GOVERNMENT OF INDIA
COMMITTEE ON PLAN PROJECTS
(IRRIGATION & POWER TEAM)

REPORT
ON
LAKKAVALLI PROJECT
MYSORE STATE

NOVEMBER 1957

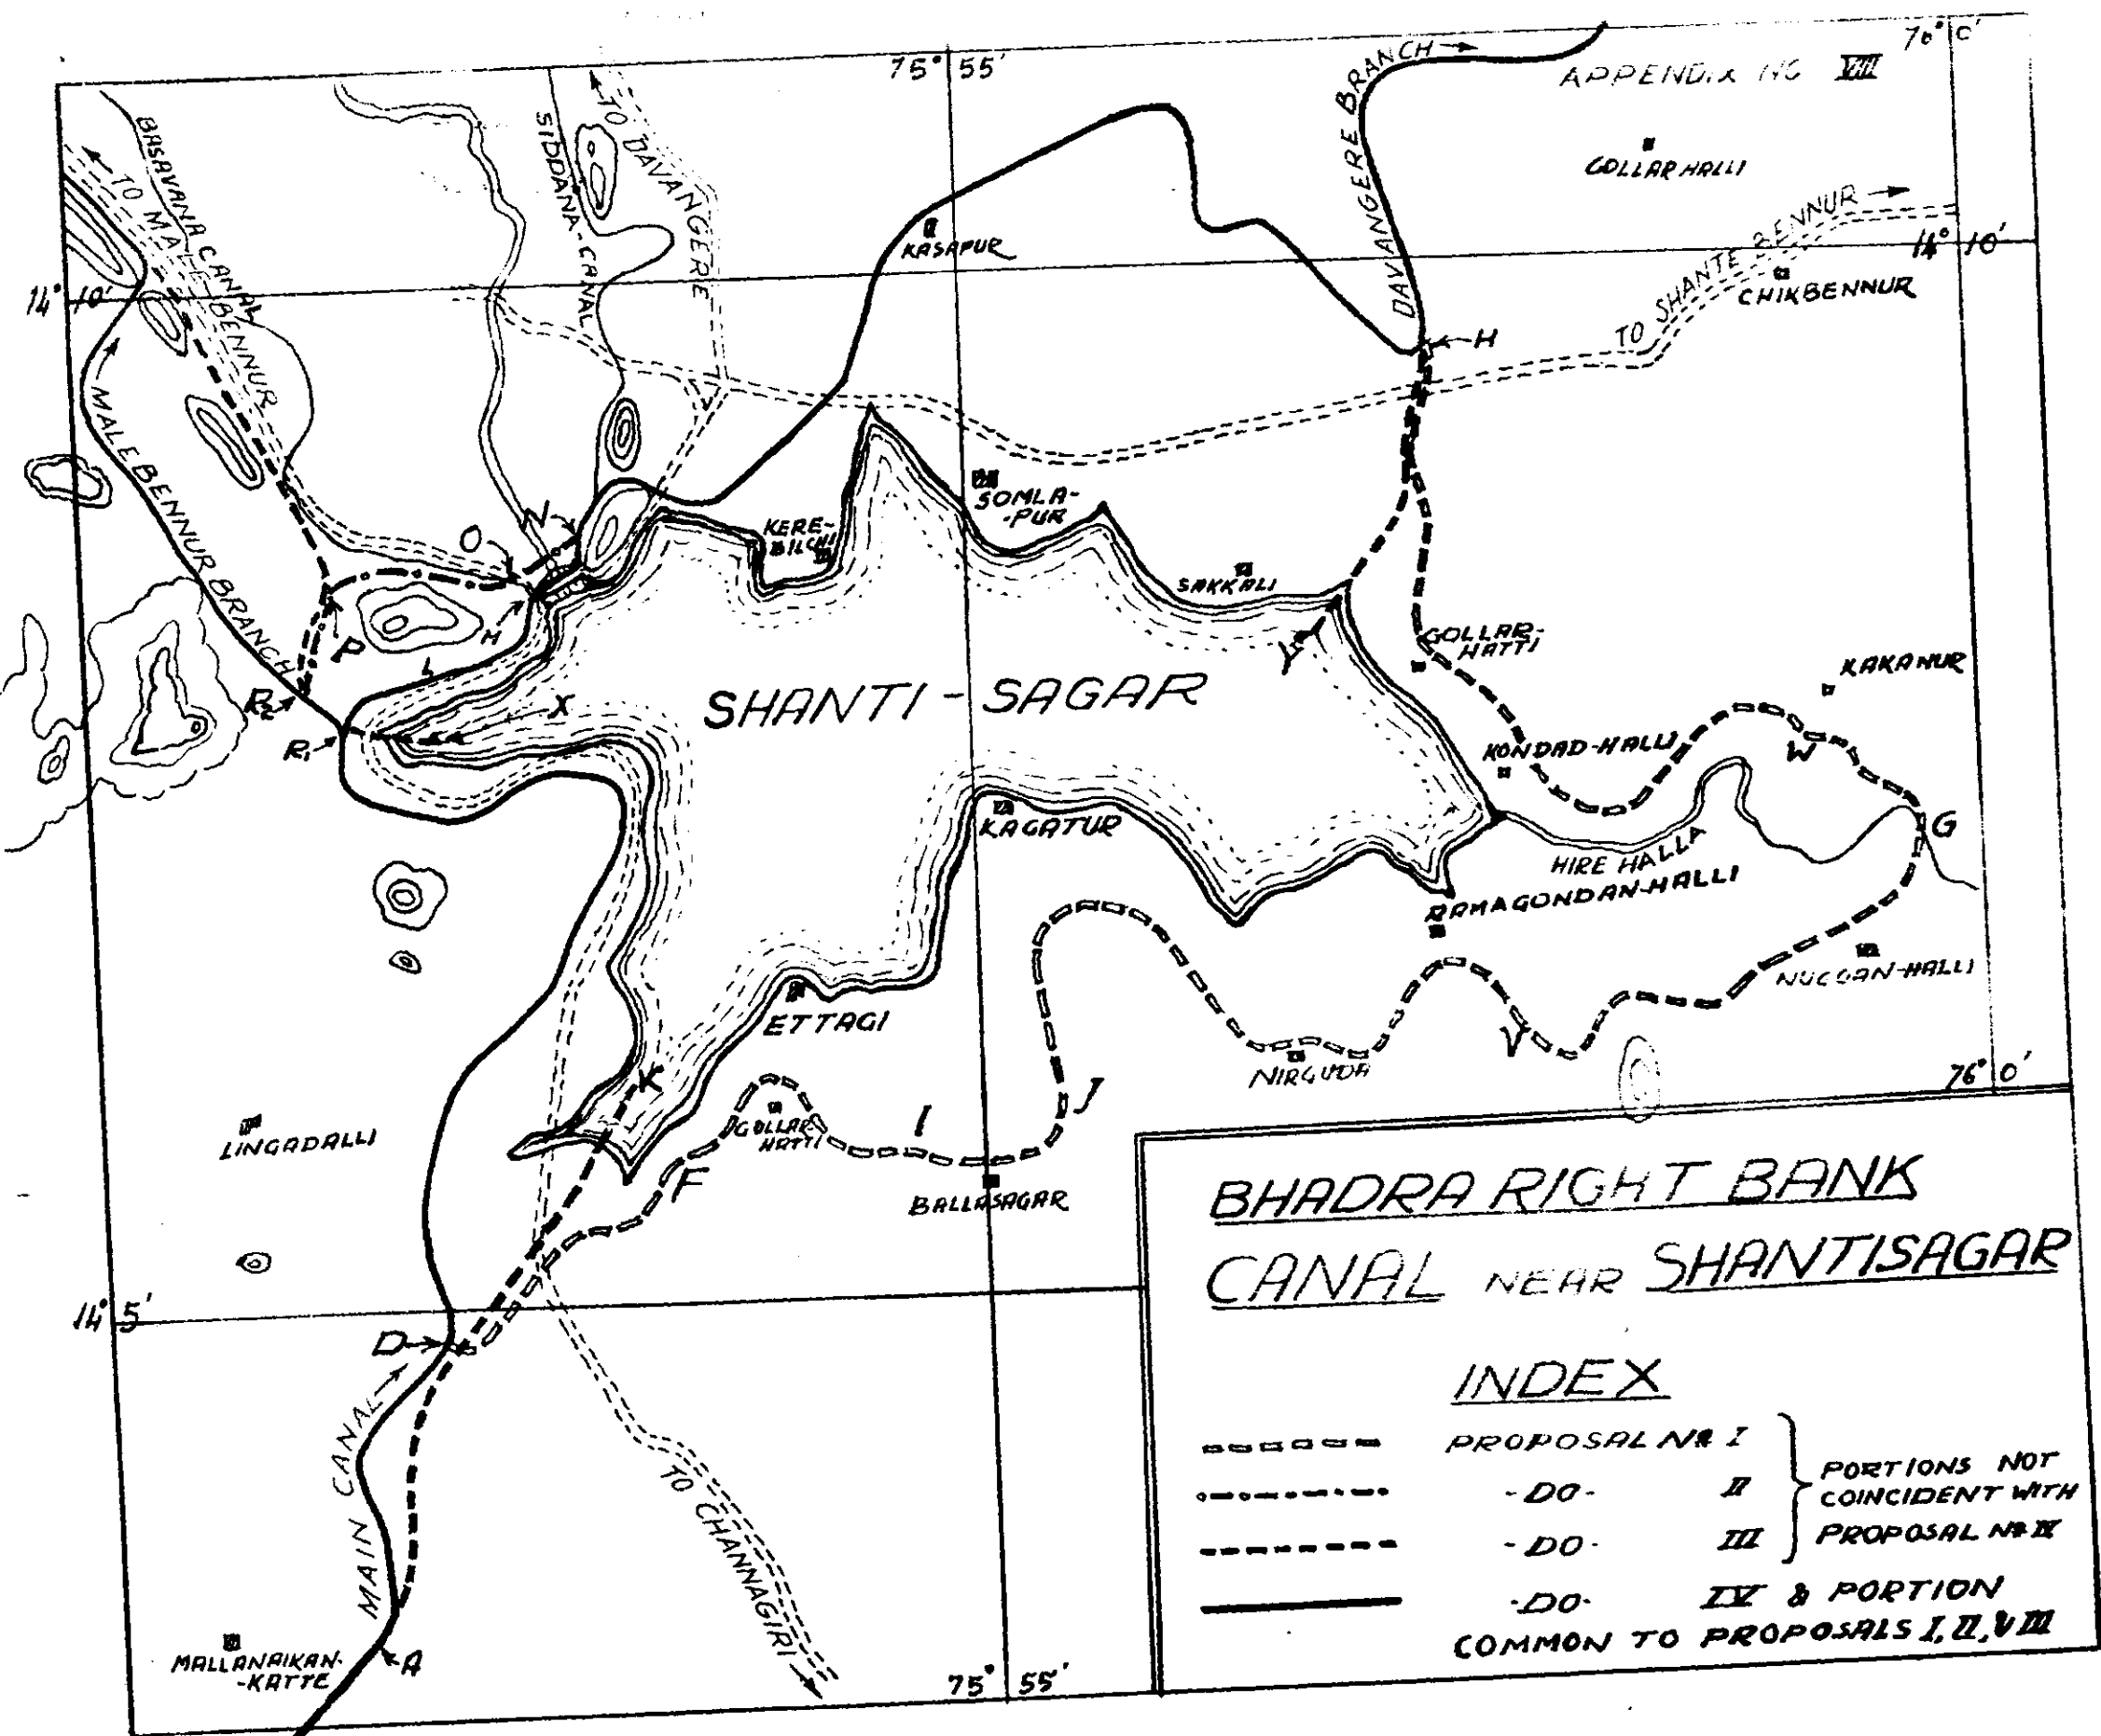
- (III) The Right Bank Channel to terminate in the tank as shown by DK in the plan. The Malebennur Branch Channel to take off from the tank along XR1 R2. The Davangere Branch Channel to take off from the tank along YH.

with a head of 90 ft. must cost more than Rs. 16 lakhs. With such high head it would be obligatory to use steel pipes, encased in concrete and the design does not provide for such construction. This major C.D. work may cost as much as Rs. 40 lakhs. This, together with the increased cost of constructing the channel length PN, mentioned earlier, is likely to increase the cost of proposal II by another Rs. 25 lakhs at least, bringing the total cost to Rs. 152 lakhs.

(a) The water level in the tank will remain at a high level throughout the year and there will be a dense growth of weeds along the shallow fringe of the lake, favourable to mosquito breeding, giving rise to a serious incidence of malaria. In the Mysore State great importance is attached to the question of health of population and to appreciate the implication of this question it is worth-while recalling the fact that 112 old tanks in the command of the Irwin Canal, ex-Krishnarajasagar reservoir had to be breached to check malaria. The condition of the affected villages has been vividly described in official reports. "Tanks in the atchkat areas situated below the channel will be full always due to the collection of seepage water from the channel, as well as from the atchkat above. Incidental to this the water table rises, dampness comes up and marshy areas are formed. All these conditions are so favourable for the breeding of mosquitoes that the area soon gets malarial and the deadly disease overtakes the population resulting in heavy mortality. Awful stories are told of the sufferings of the people due to the scourge of malaria. Several villages have gone out of existence. In some, it is said there are no male members at all, all of them having succumbed to malaria. It is even said that the young men of some of the villages affected by malaria are denied brides for marriage from other villages. The evil does not confine itself to human beings only, but has spread to cattle also. There is a terrible growth of weeds in the shallow portions of the tank water spread, which gives rise to enormous growth of snail population. The cattle that go to the tank for drinking water, catch a kind of disease called 'Liver Fluke Disease', which is due to the snails harbouring in the weeds of the tank. The breaching of tanks and other anti-malaria measures have gone a long way in mitigating the evil and restores the people of the tract to their original health and stamina in a large measure". In the face of these facts, based upon previous experience, it is not surprising that there

(b) The Malebennur and the Davangere Branch Channels taking off from the tank will have their bed levels several feet lower than those in proposal II. This factor not only results in a substantially increased cost of excavation of the channels in proposal III but to gain the same command they have to be excavated in a longer lengths. This must also result in an additional cost, which has yet to be computed.

7. Proposal IV. This proposal has none of the disadvantages of proposal III and the objectionable features of proposal II. This possibility of taking the Davangere Branch over the Sulekere bund has been examined by the Project authorities and an estimate of cost prepared. It had however been considered that it was undesirable to take the channel over the bund because the bund was old. The Team considers that it is possible to construct a reinforced concrete duct on the bund without affecting the security of the bund or causing any danger to the tank. There should be no risk in taking the channel in a concrete trough over the bund, with copper strip joints to allow for any slight settlement. The load on the foundation is of the order of half a ton per sq. ft. only. The cost of this proposal may be about Rs. 113.5 lakhs. The advantages of this proposal are:
